Hydrol. Earth Syst. Sci. Discuss., author comment AC1
<https://doi.org/10.5194/hess-2021-518-AC1>, 2022
© Author(s) 2022. This work is distributed under
the Creative Commons Attribution 4.0 License.

Reply on RC1

Author comment on "Unfolding the relationship between seasonal forecast skill and value in hydropower production: a global analysis" by Donghoon Lee et al., Hydrol. Earth Syst. Sci. Discuss., <https://doi.org/10.5194/hess-2021-518-AC1>, 2022

Figure 1.1. Scatter plots of HCC indices (Knoben et al., 2018) of 735 dams: (a) seasonality and aridity, (b) snow and seasonality, and (c) aridity and snow. Blue up-pointing (red down-pointing) triangles represent dams with good (poor) forecast skill based on $X_{M_{DAPE}}$ cut-off value.

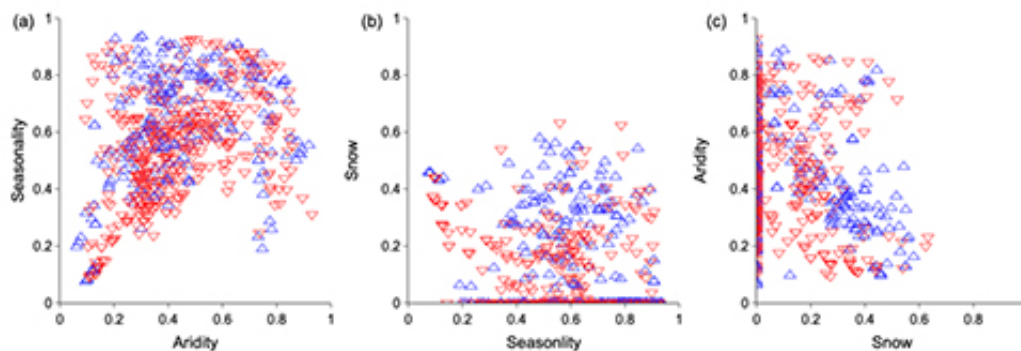
Sections 2.1 and 4.4: You decided to use the Köppen-Geiger climate classification. Since you are working hydropower and inflows which are influenced not only by climate patterns but also hydrological ones, a classification based on hydro-climate characteristics and not only climate characteristics would seem more relevant for the goal you are trying to achieve. Please consider using the hydro-climate classification proposed by Knoben et al. (2018).

Response: Thanks for suggesting the Hydrological Climate Classification (HCC) (Knoben et al., 2018). We agree with the suggestion, so we have investigated it and found the following two points. First, the HCC is derived from climate variables, such as precipitation, temperature, and potential evapotranspiration (CRU TS v3.23), and then is evaluated with independent streamflow data. Therefore, the HCC could still be seen as "climate-based" classification (although Knoben et al. (2018) showed that the HCC better represents streamflow characteristics in terms of grouping catchments). Second, the HCC is not a categorized classification like the Köppen-Geiger climate (KGC), but rather a set of three dimensional numerical climate indices, including annual aridity, aridity seasonality, and precipitation-as-snow. As a result, categorizing dams according to their hydroclimatic characteristics is not straightforward.

Although it is beyond the scope of our original goal--which is classifying forecast accuracy over climate zones--we analyzed the relationships between HCC indices and forecast skills of 735 dams (see the figure below). Here, we used averaged HCC values in the grids upstream of each dam. Figure 1.1 (reported below) illustrates forecast skills of 735 dams at the given HCC values. Some interesting patterns can be identified, such as dams in the snowing regions (snow ≥ 0.2) tend to have good forecasts with higher seasonality (seasonality ≥ 0.4) (panel b) or less aridity (aridity < 0.4) (panel c). We believe such interpretation can contribute to characterize dams' forecast skills at the given hydrological and climate conditions. However, we plan to include this analysis in the supplementary information according to the aforementioned two points.

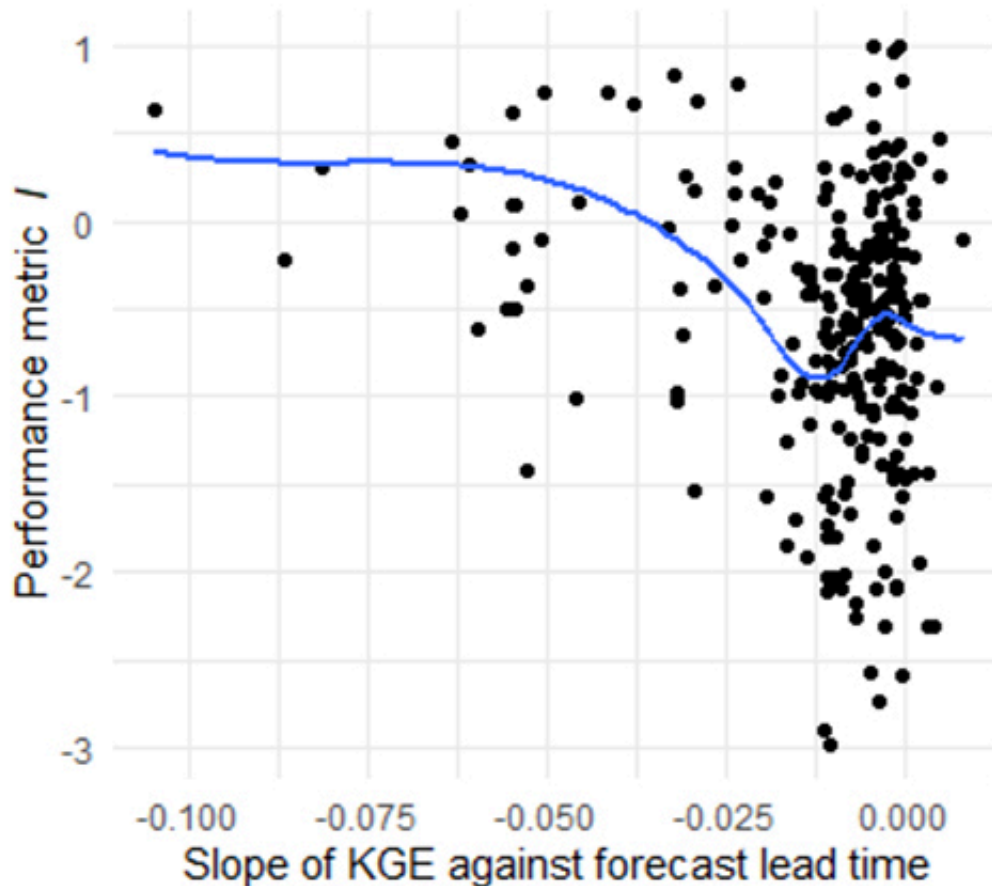
L.320-321 "Considering the superior performance of the MP1 model, the forecast skill of MP1 only is retained to represent the overall forecast skill in the following analyses." Since the optimisation uses all forecast horizons, the speed with which skill decreases with the forecast horizon may play a role in the optimization and could have been considered as well.

Response: Thank you for raising this point. It is indeed true that the speed with which forecast skill decreases may play a role. To investigate this, we first fit a linear regression between KGE and prediction lead time for each of the 269 dams classified as success cases. We then use the slope of the regression to represent the speed with which forecast skill decreases (i.e., a highly negative slope means forecast skill drops quickly with longer lead-times). We then plot the performance metric I against the slope (Figure 1.2). There is no clear trend of correlation between the speed with which forecast skill decreases and forecast value. Given this result, we believe that such analysis should be reported in the supplemental material, but not in the main manuscript.

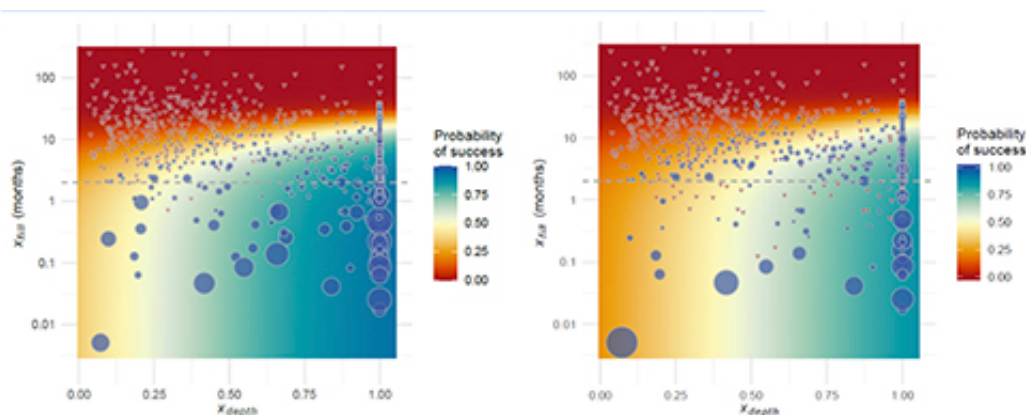
L355-357 “This is attributed to the weekly operations, suggesting that more frequent release decisions may reduce forecast value, since the benchmark operating rules have more opportunities to adjust release decisions.” Isn’t it the case for all the dams below the horizontal line? Why should these ones (the failing ones) behave differently?

Response: Our original intention was to make a comparison between weekly operations and monthly operations. For all dams below the horizontal line, weekly operations reduce forecast value as shown in the figure below. We did not mean to make a comparison between the failing dams and the successful ones below the horizontal line. We realize that this statement can be misleading, hence we will revise it to clarify our point:

"This is because weekly operations decrease IPF for some of these dams to below the mean IPF, turning them from cases (if operated on a monthly basis) into non-cases. This suggests that more frequent release decisions may reduce forecast value, since the benchmark operating rules have more opportunities to adjust release decisions."
